LANDSIDE ACCESS MODERNIZATION PROGRAM

ITF-W_A Interim Ground Access (IGA) **Project # DA-5305A**

Package Transmitted For	Delivered Via	Tracking Number
CO-0008-PDG FULLY EXECUTED ITF-W A Interim Ground Access (IGA) Change Order #08 for CPCN No# 1007A, 1004A, 1003A, and 1011A 2019-06-21		CO-0008-PDG FULLY EXCUTED

CHANGE ORDER NO. 0008

Unforeseen Storm Drain Line Near Sanitary Sewer Line
Connection Location.

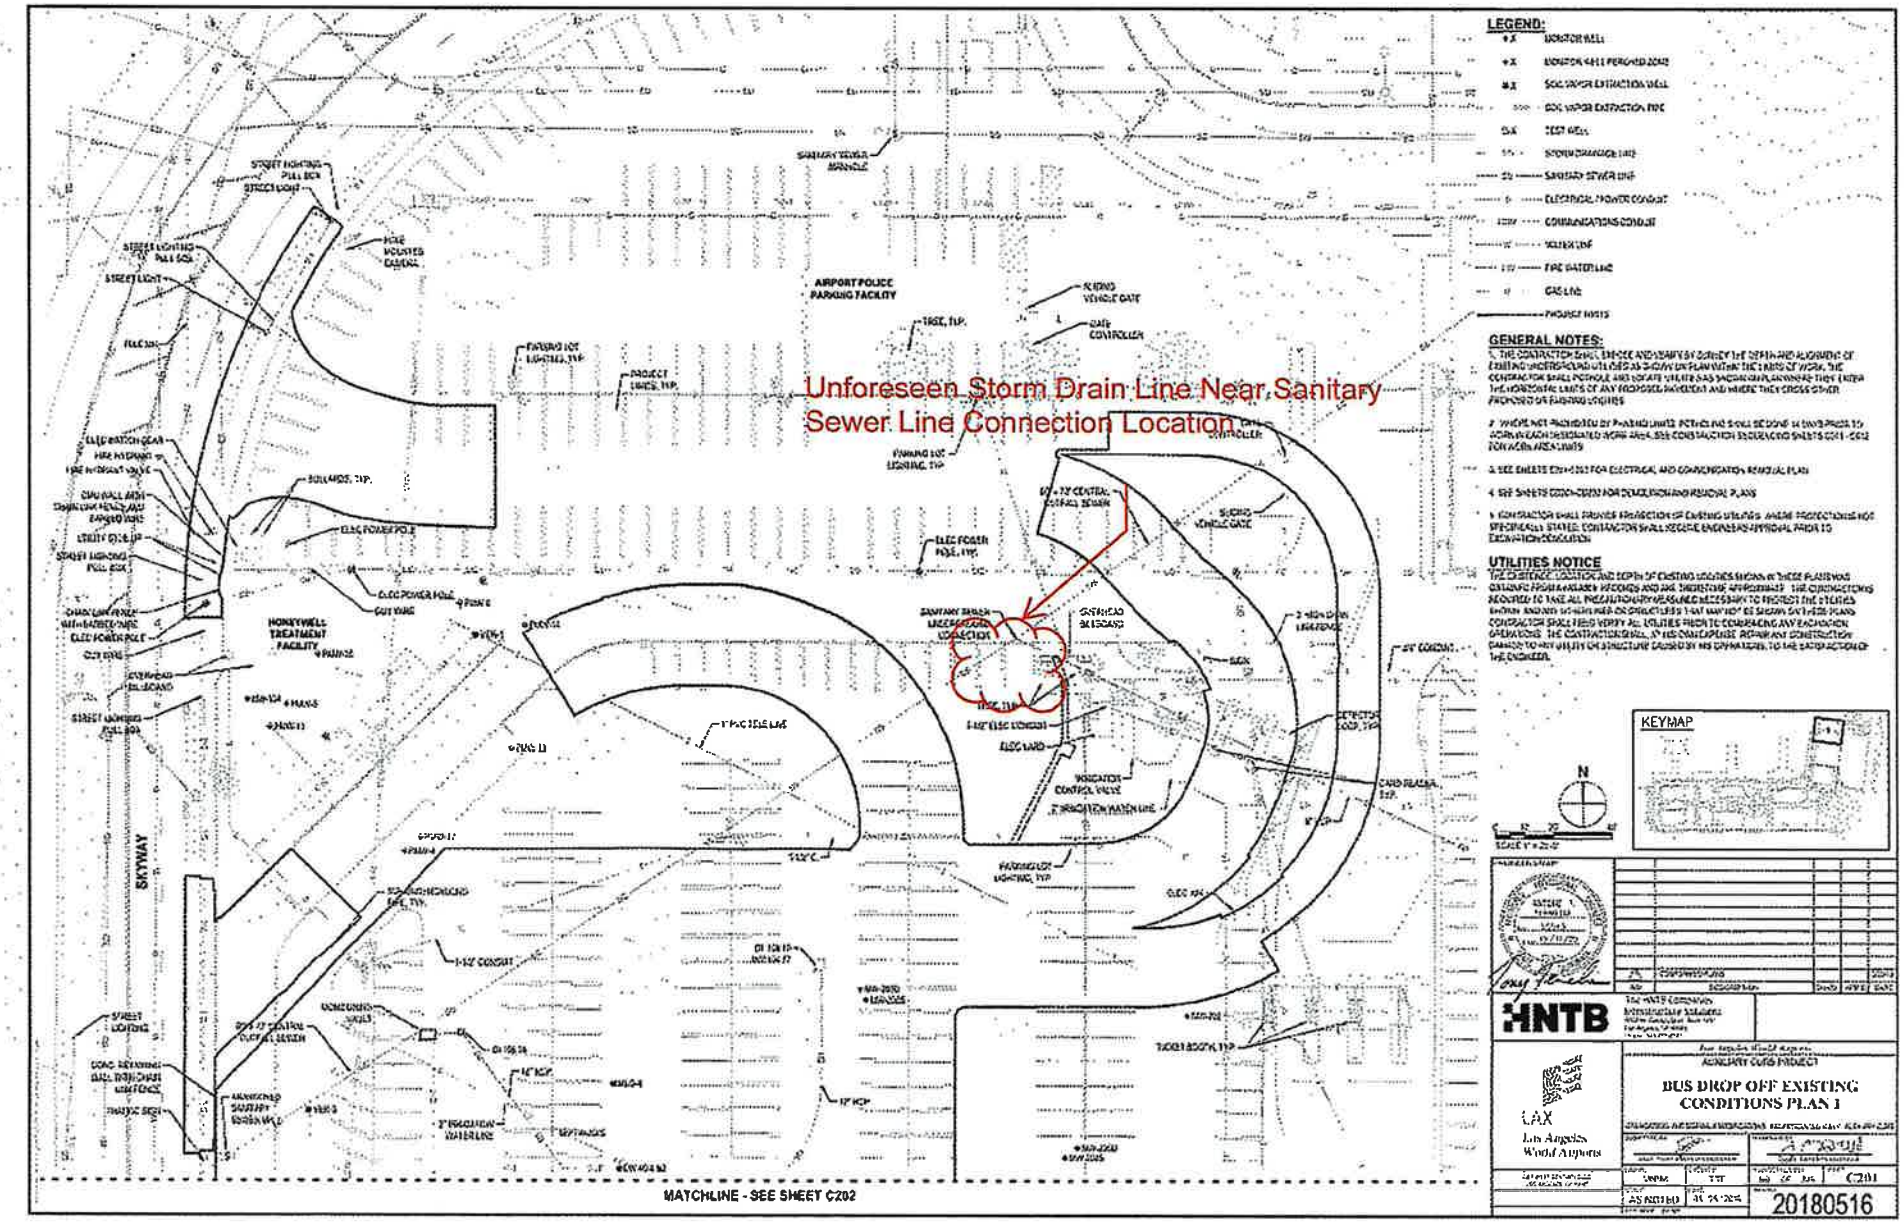
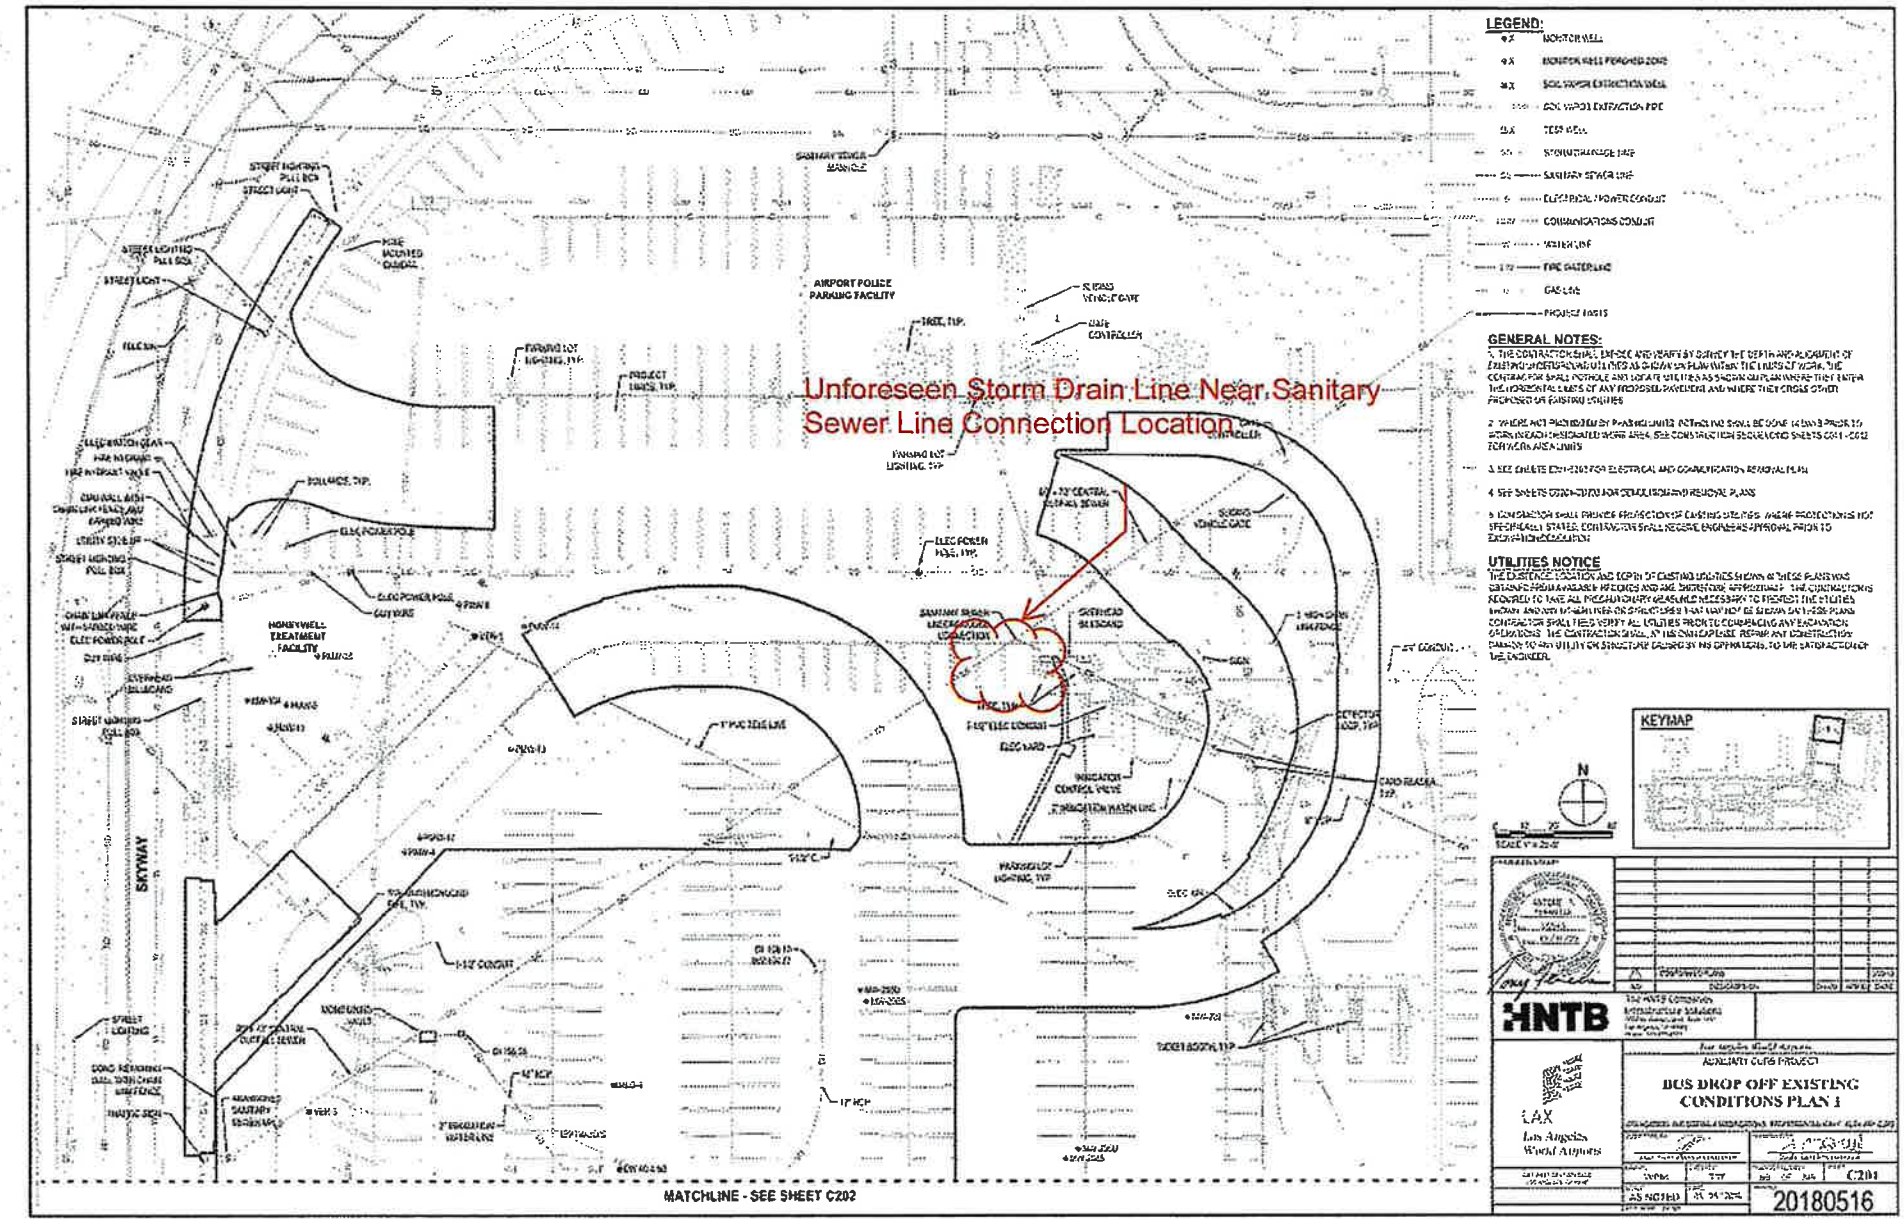
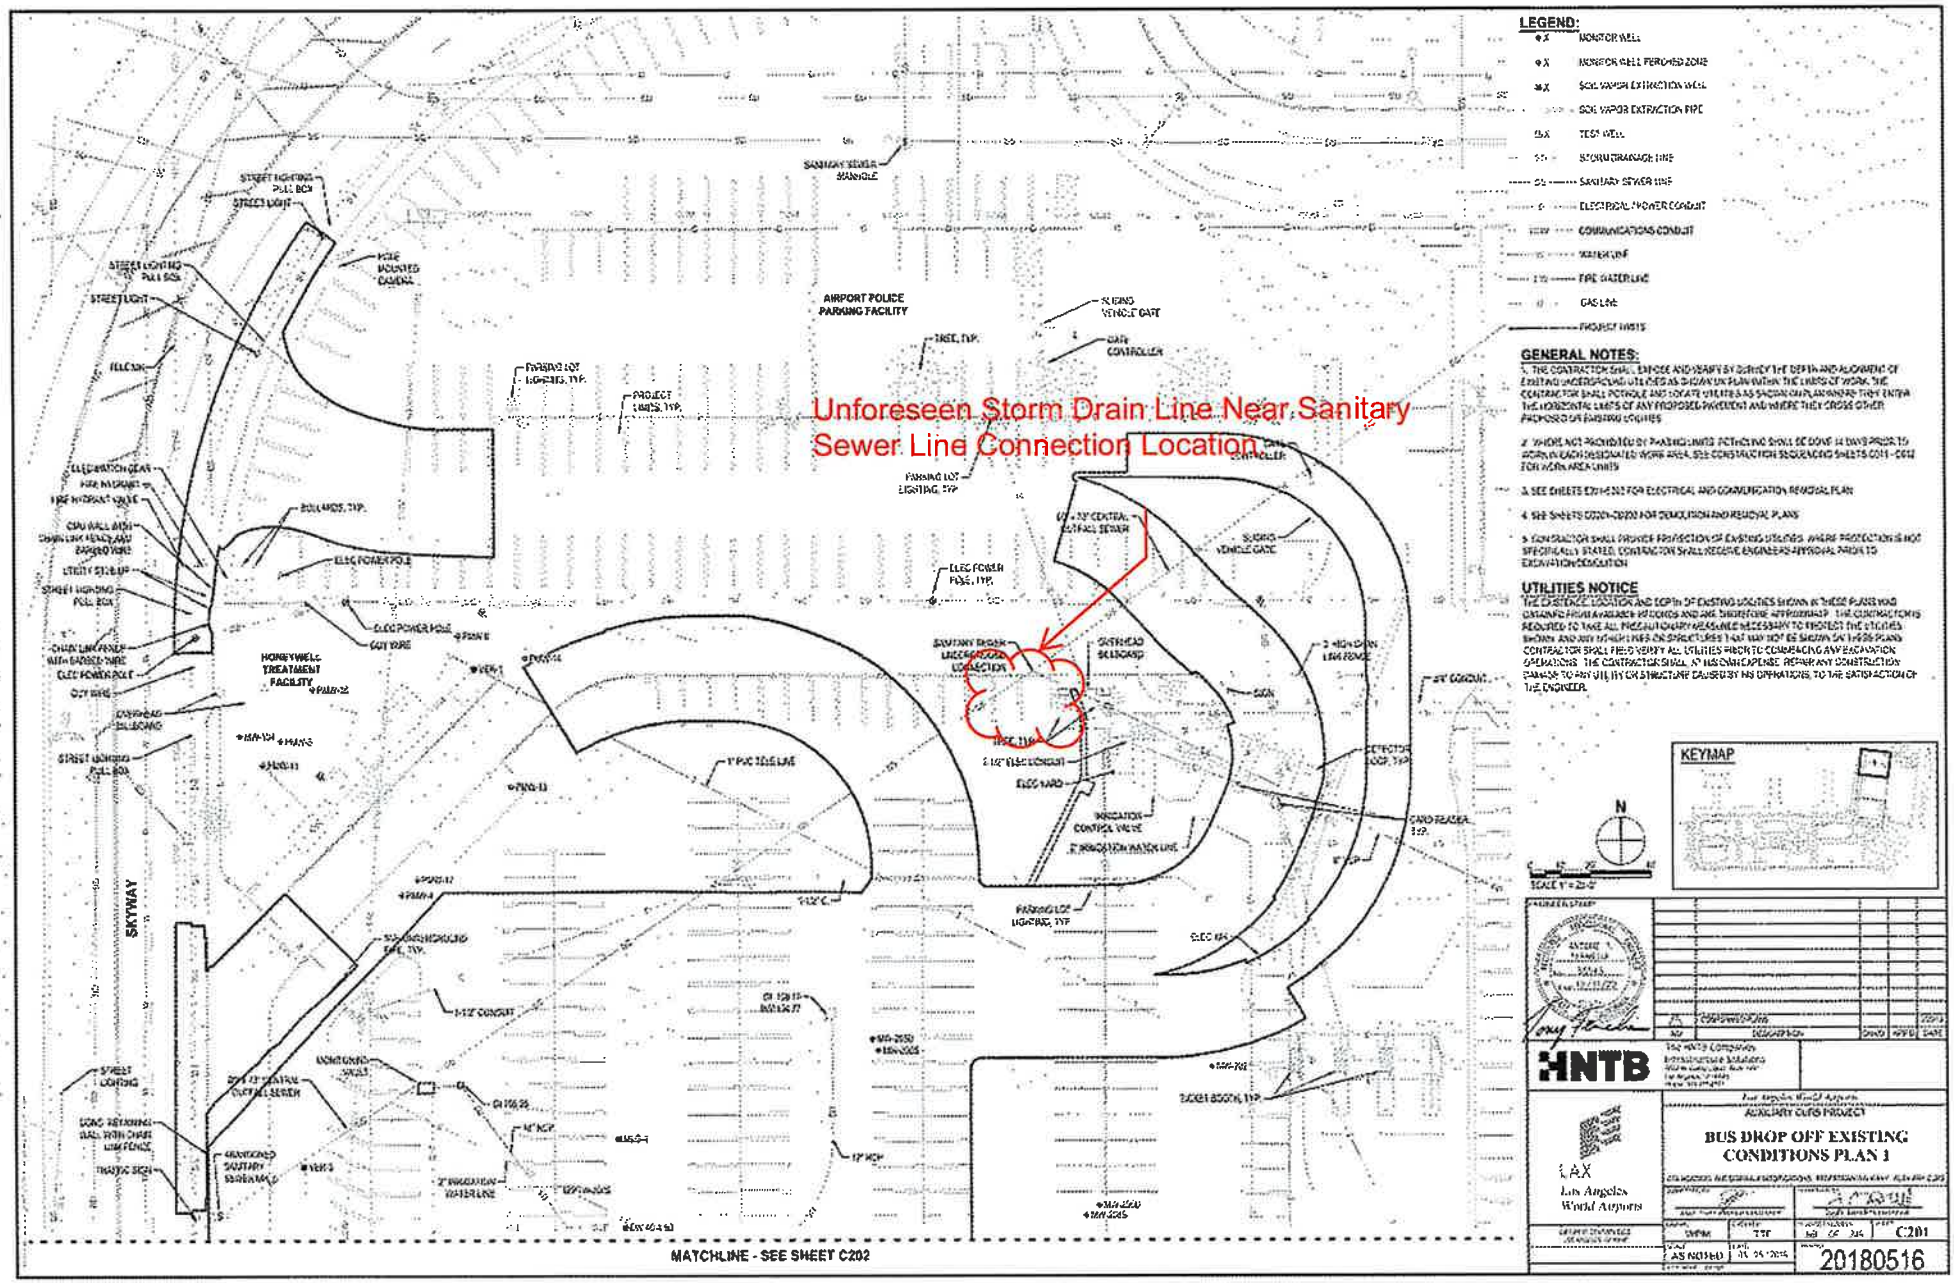
Unforeseen Storm Drain Line Near Sanitary Sewer Line Connection Location
LEGEND:
GENERAL NOTES:
UTILITIES NOTICE
KEYMAP
AIRPORT POLICE PARKING FACILITY
HONEYWELL TREATMENT FACILITY
SKYWAY
MATCHLINE - SEE SHEET C202
HNTB
LAX
Los Angeles World Airports
BUS DROP OFF EXISTING CONDITIONS PLAN 1
C201
20180516

If the existing drain line is abandoned, it is acceptable to remove interfering portions or abandon it. Otherwise, it should be repaired.
